DART AEROSPACE LTD		Work Order:	151601
Description: Crosstube Assembly (AS350/355 High Aft SS)		Part Number:	D350-748-243
Inspection Dwg: D350-748-243 Rev: A		Page 1 of 2

DART AEROSPACE LTD HAWKESBURY, ONTARIO, CANADA	
DRAWING NO. D350-748-243	REV. A SHEET 1 OF 4
TITLE CROSSTUBE (AS 350/355 HI AFT)	SCALE NTS
COPYRIGHT © 2015 BY DART AEROSPACE LTD THIS DOCUMENT IS PRIVATE AND CONFIDENTIAL AND IS SUPPLIED ON THE EXPRESS CONDITION THAT IT IS NOT TO BE USED FOR ANY PURPOSE OR COPIED OR COMMUNICATED TO ANY OTHER PERSON WITHOUT WRITTEN PERMISSION FROM DART AEROSPACE LTD.

DRAWING NO. D350-748-243	TITLE CROSSTUBE	REV. A	DART AEROSPACE LTD ENGINEERING ORDER		D.E.O. NO. D350-748-243-A-1	SHEET NO. SHEET 1 OF 1	SCALE NTS
DRAWN <i>qp</i>	CHECKED <i>ASS</i>	MFG. APPR. <i>[Signature]</i>		APPROVED <i>[Signature]</i>	DE APPR. <i>[Signature]</i>		
DATE 15.11.18	DATE 15.11.18	DATE 16.02.19		DATE FEB 19 2016	DATE 2016.02.19

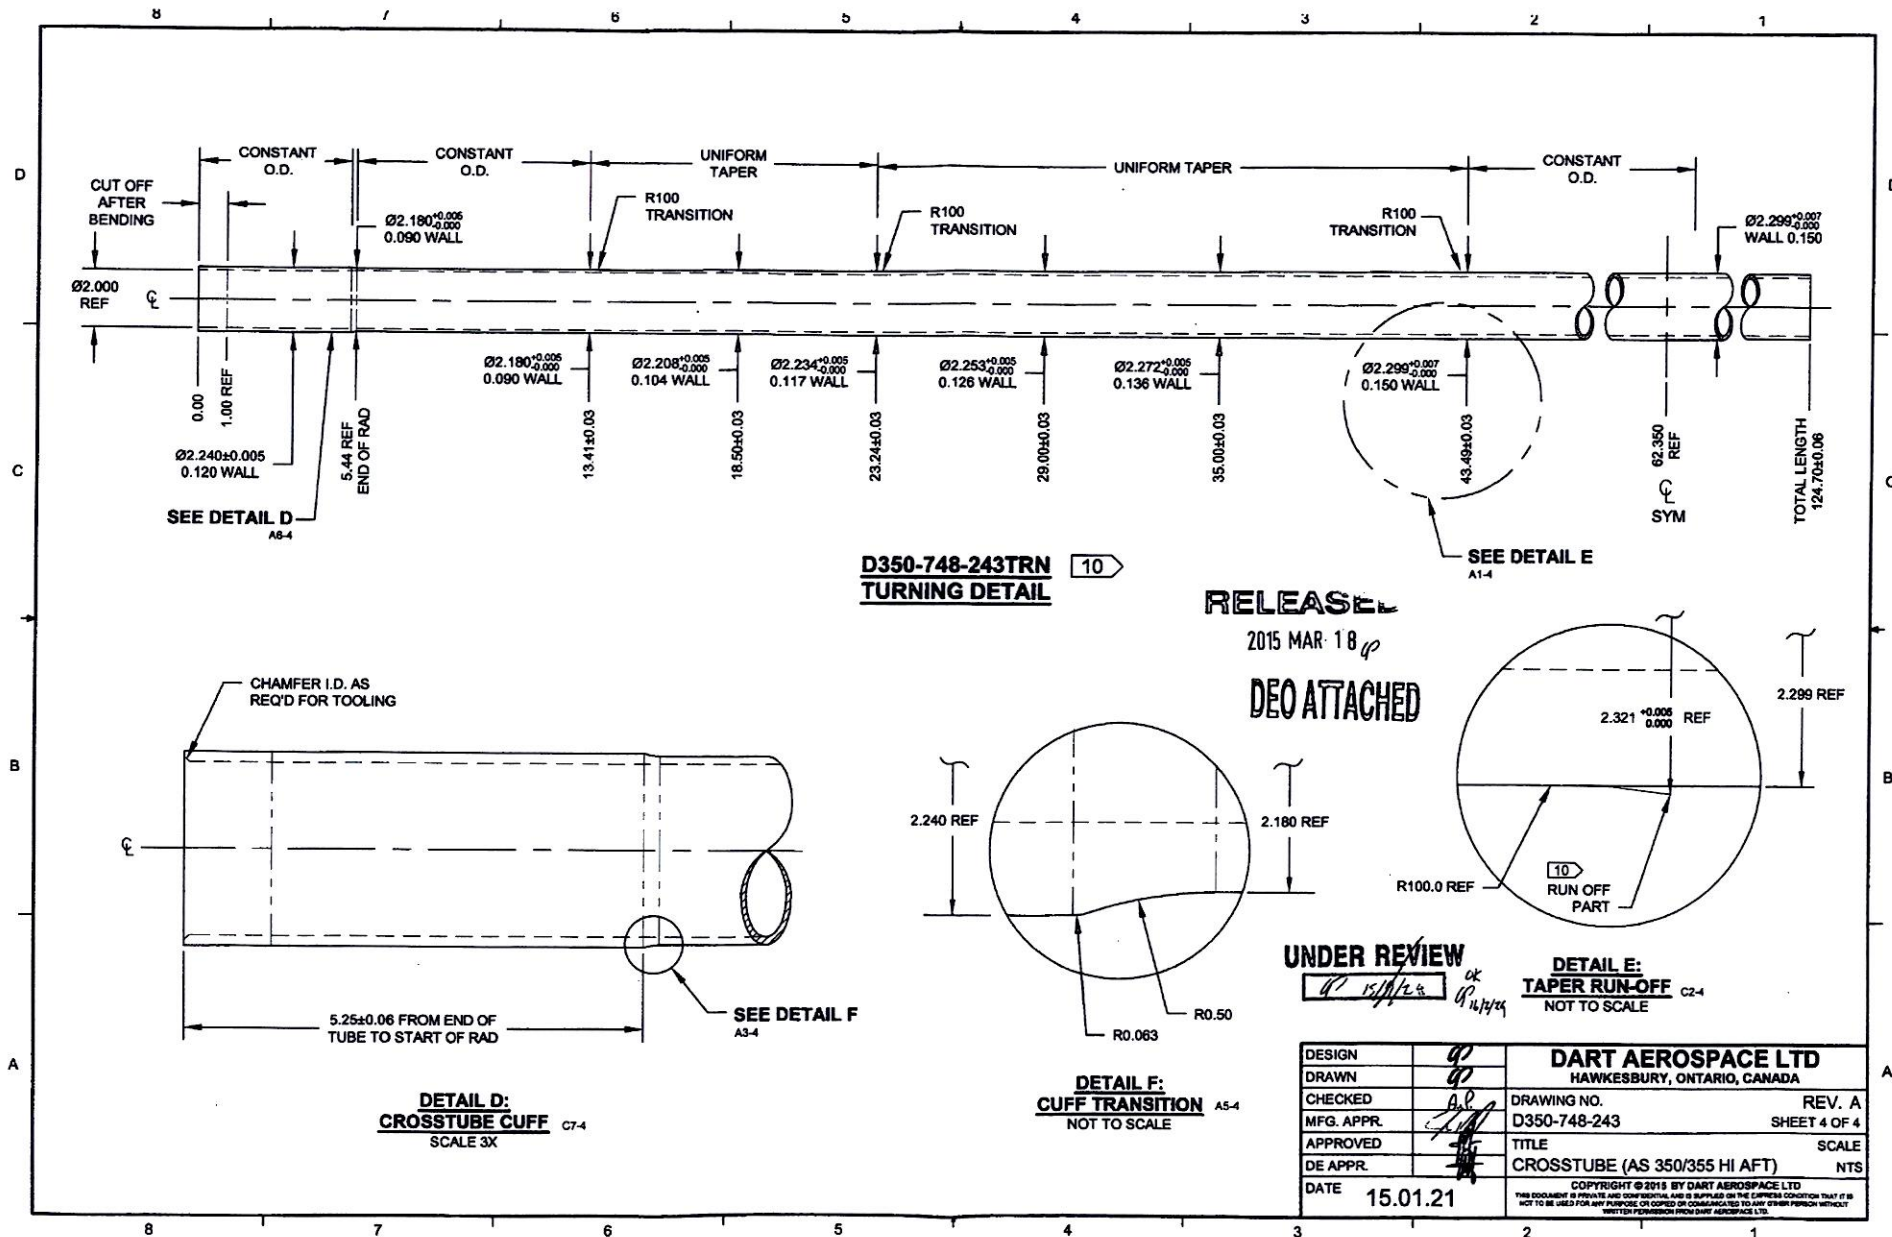
AMEND NOTE 2 (SHEET 1) AS FOLLOWS:

- 2) FINISH: PREPARE SURFACE PER DART QSI 005 4.1.4
 PRIME INSIDE AND OUTSIDE PER DART QSI 005 4.2
 PAINT OUTSIDE PER DART QSI 005 4.2
 OR
 POWDER COAT WHITE (4.3.5.2) PER DART QSI 005 4.3
